AGENDA
PLANNING COMMISSION
116 WEST NEEDLES
BIXBY, OKLAHOMA
May 20, 2013 **6:00 PM**

8. **BSP 2013-02 – Panda Express – Bannister Engineering, LLC (PUD 67).** Discussion and possible action to approve a PUD Detailed Site Plan and building plans for “Panda Express,” a Use Unit 12 restaurant development for part of the NW/4 SW/4 of Section 25, T18N, R13E.

9. **BSP 2013-03 – Grand Bank – Sisemore, Weisz & Associates, Inc. (PUD 65).** Discussion and possible action to approve a PUD Detailed Site Plan and building plans for “Grand Bank,” a Use Unit 11 bank and retail development for Lot 5, Block 1, *101 Memorial Square.*

To: Bixby Planning Commission
From: Erik Enyart, AICP, City Planner
Date: Friday, April 26, 2013
RE: Report and Recommendations for:
*PUD 77 – “Byrnes Mini-Storages” – JR Donelson, Inc., and
BZ-365 – William W. Wilson for Helene V. Byrnes Foundation*

SHEET NAME:
ST-3.0

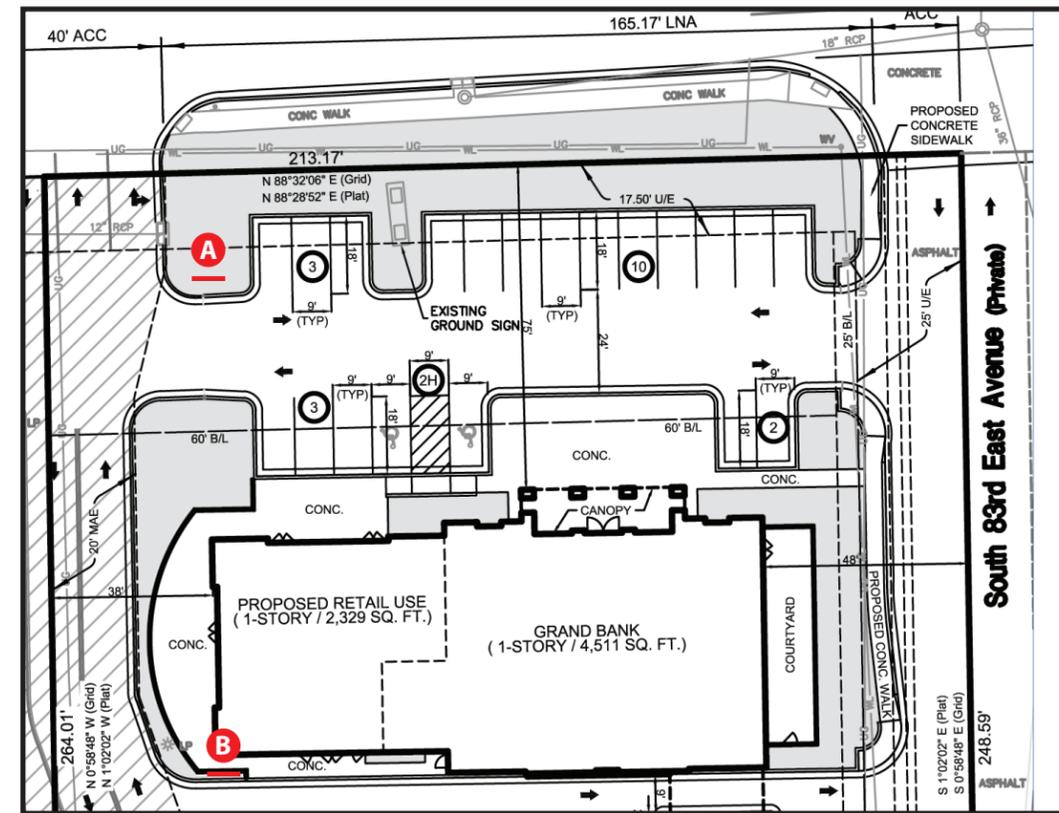
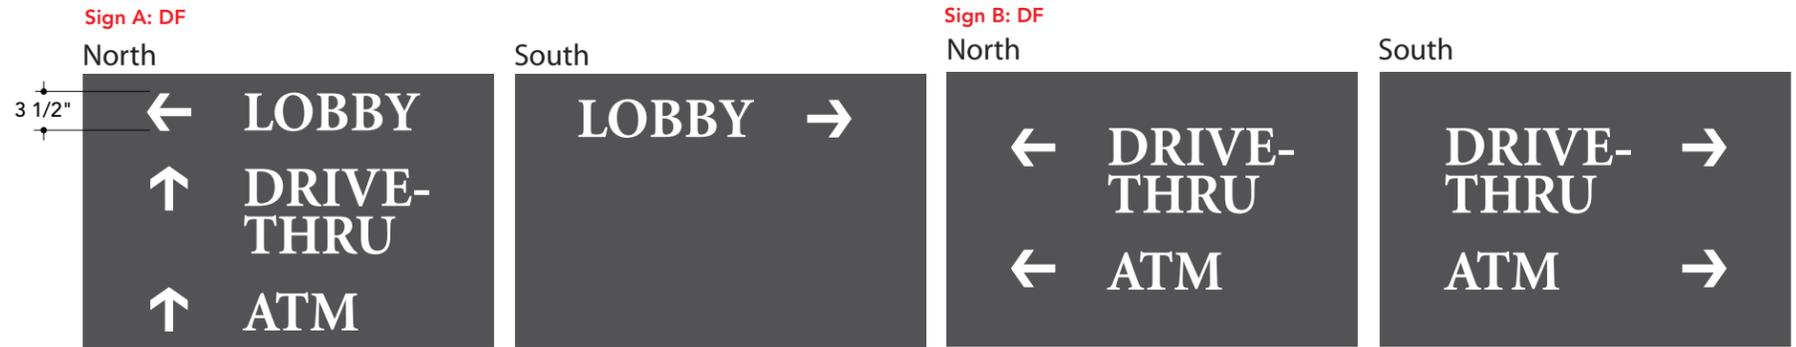
Most commercial developments of this size will have incidental signage for traffic control and general identification information, and the ST-3.0 drawing indicates the locations of two (2) directional signs. Zoning Code Section 11-9-21.C.3.k allows standard directional signs at a maximum of three (3) square feet in display surface area, but each would have six (6) square feet. However, they may be permitted as the second ground sign allowed on the 101st St. S. frontage, and the first allowed on the 83rd E. Ave. frontage, and the aggregate display surface area will not exceed that allowed by Zoning Code Sections 11-7I-4.B.3.b and 11-9-21.D.3.
